MODIFICATION OF DISK DRIVE DATA CABLE AT DRIVE END.

XEROX	UNI-GRANT	DIABLO CABLE MOD FOR SWITCHABLE DP0/DP1	CREATOR: R.REYES	FILE: DIABLO DISKSW.SIL	REV. A	DATE: 01-24-80	PAGE: 1

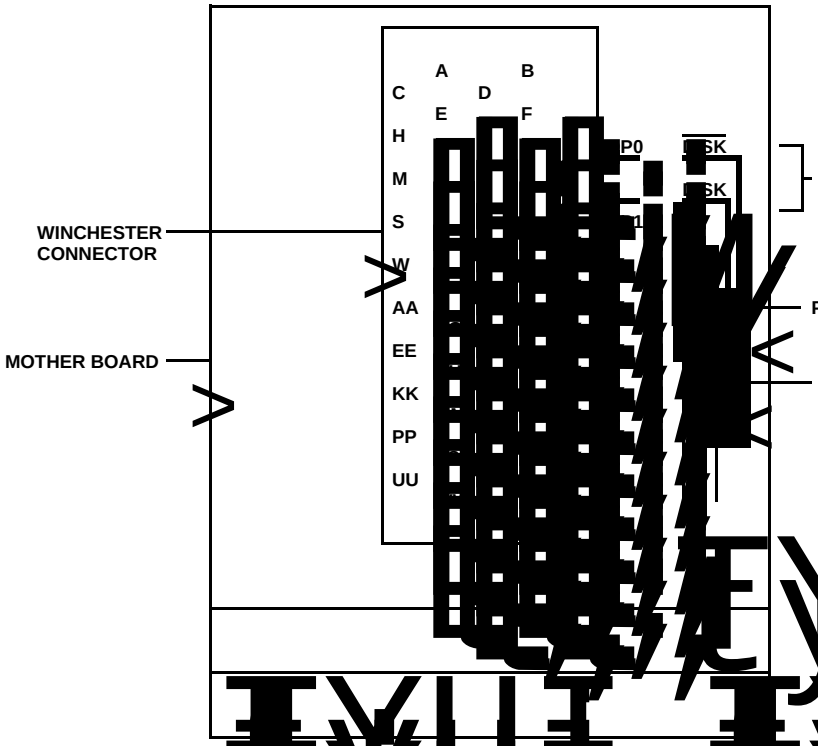
CUT PRINTED WIRE GOING TO WINCHESTER CONNECTOR PIN L.
CUT PRINTED WIRE GOING TO WINCHESTER CONNECTOR PIN R.
INSERT RIBBON CABLE THROUGH EXISTING HOLE ON WINCHESTER CONNECTOR MOTHER BOARD. SOLDER PRE-LABELED RIBBON CABLE WIRES TO PRINTED WIRES ON MOTHER BOARD AS SHOWN.

MINIATURE DPDT SWITCH WIRING

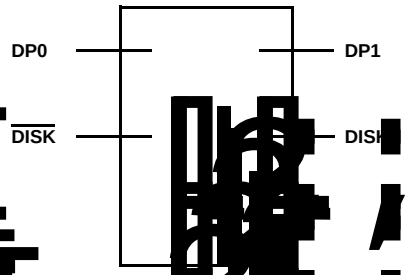
SOLDER JUMPERS AND OTHER END OF PRE-LABELED RIBBON CABLE AS SHOWN.

CABLE BETWEEN ALTO AND DISK DRIVE

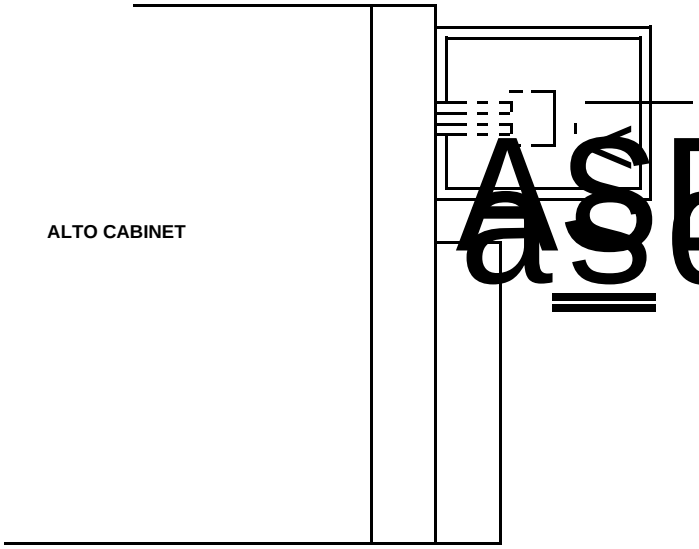
PLACE DPDT SWITCH ON LEFT SIDE OF DISK DRIVE FRONT PANEL
USE CLEAR RUBBER CEMENT OR EQUIVALENT TO ADHERE SWITCH TO DISK DRIVE FRONT PANEL.
DPDT SWITCH SHOWN IN DP0 (NORMAL) POSITION.
CABLE CAN BE ROUTED BETWEEN TOP OF ALTO CABINET AND DRIVE.

NOTE: LEAVE ENOUGH CABLE SLACK TO ALLOW REMOVAL OF DISK DRIVE COVER; FOR MAINTENANCE.
SECOND DISK DRIVE CAN BE REMOVED WITHOUT CAUSING PROBLEMS IF SWITCH IS PLACED IN NORMAL POSITION (I.E., ALTO DISK DRIVE IS ADDRESS ZERO.)
